Project : 2X660MW KHURJA SUPER THERMAL POWER PROJECT

Package: Lighting Fixtures, Lamps & Misc. items

CORRIGENDUM-4

PROJECT 2X660 KHURJA TPP					
CRS sheet: Service building ARCHITECTURAL PLAN DRAWINGS					
NTPC Drawing No	Drawing Title	NTPC Comments 08.07.2021	BHEL REPLY 23.07.2021	NTPC Comments 16.08.2021	BHEL REPLY 01.10.2021
9915-371-110-PEM-PVC-V-351	Architectural Ground Floor Plan at EL (+)0.00 M	1. Two Rolling shutter in AC Plant Room	Noted & Incorporated.	1. Indicate clear height of MCC room. Height of MCC room with bus duct shall be min. 4500mm	The floor to floor height of MCC ROOM consider is 4.25 as per Technical specification.

TITLE		APP'D	REVISED	ANL	11/15/21
SERVICE BUILDING					
FIRST FLOOR MASONRY LAYOUT & D/W SCHEDULE AT EL (+)4.25M

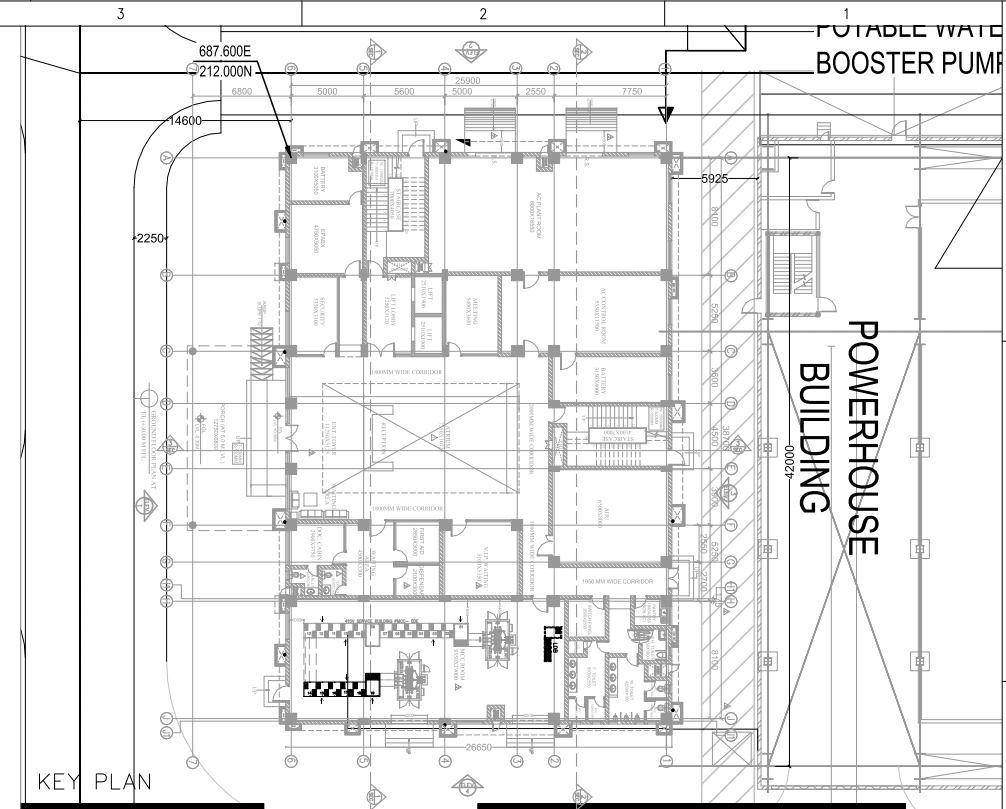
15. Please confirm to clause no. 5.02.04 Service Building and provisions of service building in Chapter 9 of Civil Work Specification	Noted and comply as per consider for GRIHA BUILDING DESIGNING.		
9915-371-110-PEM-PVC-V-352	Architectural First Floor Plan at EL (+)4.25 M	1. Dimension from Power House Building	Noted & Incorporated.	1. Revise the layout near the pantry area in reference of pantry door , J.C. and drinking water location.	Noted, to maintain the privacy and seggreagte the toilet area passage with pantry the layout has been changed. Kindly review.

2. Mark Door in Workstation area	Noted & Incorporated.	2. Mark the screen wall in front of the toilet near conference room.	Noted, Screen wall is marked in front of the toilet.

3. Check Toilet Size	Layout revised and updated.	3. Revise the Floor Level as per height of MCC room	No change in MCC room height as per dscussion with THDC/ NTPC.

4. Re- Workout Toilet and Pantry Layout	Layout revised and updated.	4. please refer to comments on drg 9915-371-110-PEM-PVC-V-352-01	Noted and provided.

5. Mark Front passage in atrium area	1800mm front passage is marked as per comment
9915-371-110-PEM-PVC-V-353	Architectural Second Floor Plan at EL (+)8.5 M	1. Check Toilet Size	Layout revised and updated.	1.Outside title of the drawing is SERVICE BUILDING : SECOND FLOOR MASONRY LAYOUT & D/W SCHEDULE Please correct this requesting to TASK FORCE BEFORE NEXT REVISION SUBMISSION	Noted,Drawing Title is revised as per MDL title

THIRD FLOOR MASONRY LAYOUT & DW SCHEDULE AT EL +12.75M

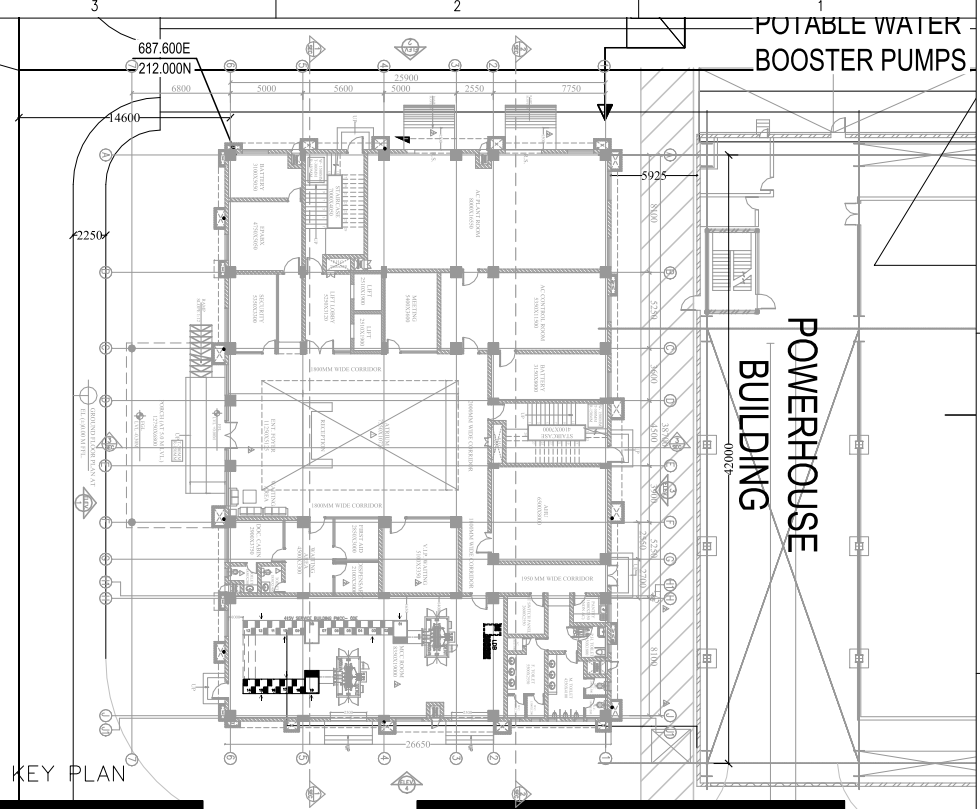
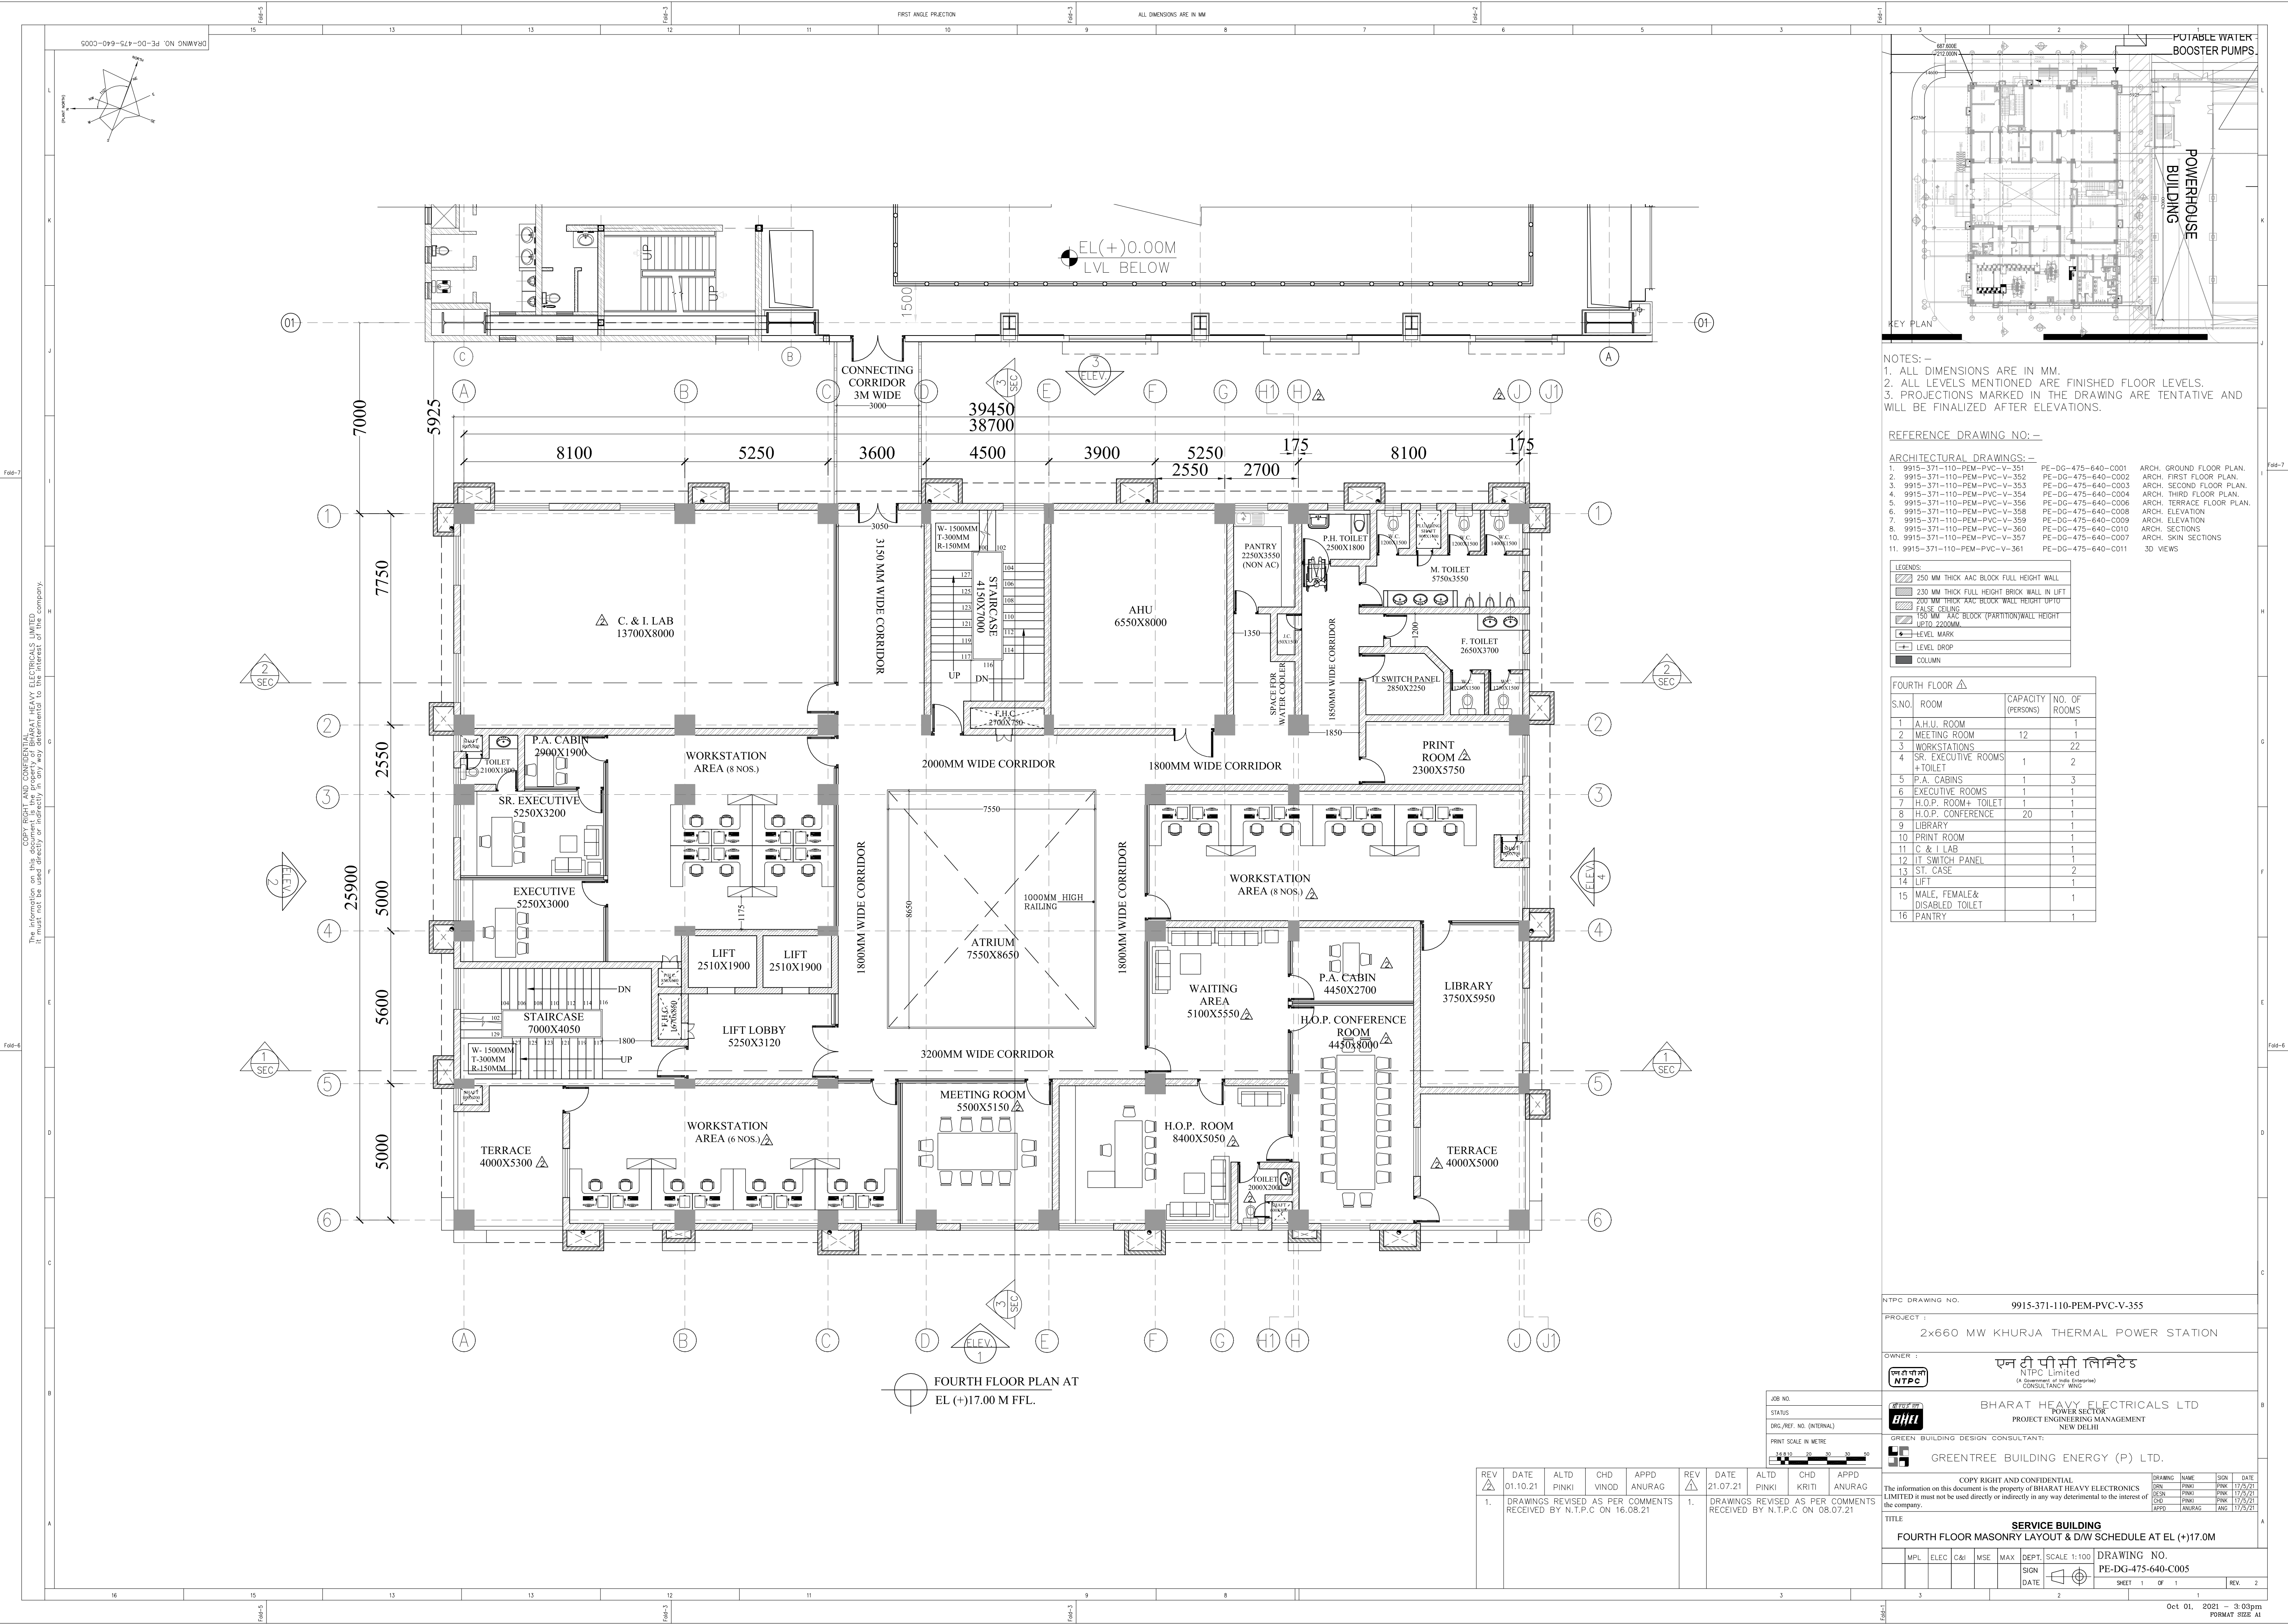
9915-371-110-PEM-PVC-V-354	Architectural Third Floor Plan at EL (+)12.75 M	1. Check Toilet Size	Layout revised and updated.	1. Revise the Floor Level as per height of MCC room	No change in MCC room height.

2. Mark Door in Workstation area	Noted & Incorporated.	2. Please refer to comments on 9915-371-110-PEM-PVC-V-352-0	Noted and provided.
		2. Move Executive Room Wall	Noted & Incorporated	3. Revise the layout near the pantry area in reference of pantry door, J.C. and drinking water location.	Noted, to maintain the privacy and seggreagte the toilet area passage with pantry the layout has been changed. Kindly review.

4. Re- Workout Toilet and Pantry Layout	Layout revised and updated.	4. Revise the Atrium cutout area	
9915-371-110-PEM-PVC-V-355	Architectural Fourth Floor Plan at EL (+)17.00M	1. Check Toilet Size	Layout revised and updated.	1. Revise the Floor Level as per height of MCC room	ATRIUM cutout area has not been increased as it will reduce the seating capacity same will be dicussed and expained during meeting.

TITLE
FOURTH FLOOR MASONRY LAYOUT & DW SCHEDULE AT EL (+)17.00M
DRAWING NO. PE-DG-475-640-C005
SHEET 1 OF 1

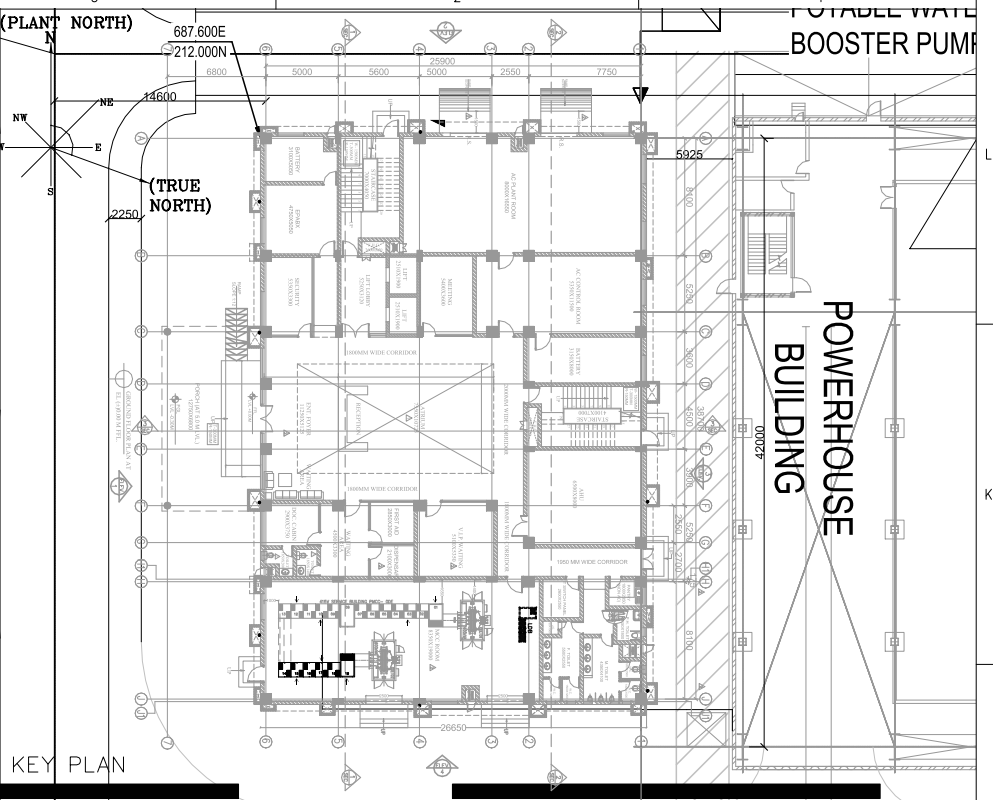
2. Mark Door in Workstation area	Noted & Incorporated.	2.Please refer equipment layout and revise connecting corridor location. Accordingly Service building arrangement to be revised.	The connecting Corridor provide at 17.00 m level are as per the equipment layout drawing

3. Move Door in Library	Noted & Incorporated.	3.please mark the dimensions and confirm if centre line is matching of connecting corridor.	Noted.as per the structural column layout at ground and other floor the location has been provided.

4. Re- Workout Toilet and Pantry Layout	Noted & Incorporated	4. Kindly relocate print room as the area of C&I lab seems less.	Print Room location is revised and located near the Library .

5. The Approach Corridor revised to 3 m. width	Layout revised and updated.	5. C&I lab shall be air conditioned and false ceiling height shall be min 3 mtrs from FFL	Noted. The false ceiling heght will be 2.8 as the floor to floor height will be 4.25 m as per specification.false ceiling layout will be covered in false ceiling drawings.

6. Revise the Atrium cutout area	Noted. REF reply above.
				7. Revise the layout near the pantry area in reference of pantry door, J.C. and drinking water location.	Noted. REF reply above.
9915-371-110-PEM-PVC-V-356	Architectural Terrace Plan at EL (+)21.25M	1. Mark Cage Ladder	Noted & Incorporated	1. Revise the Floor Level as per height of MCC room	No change in MCC room height.
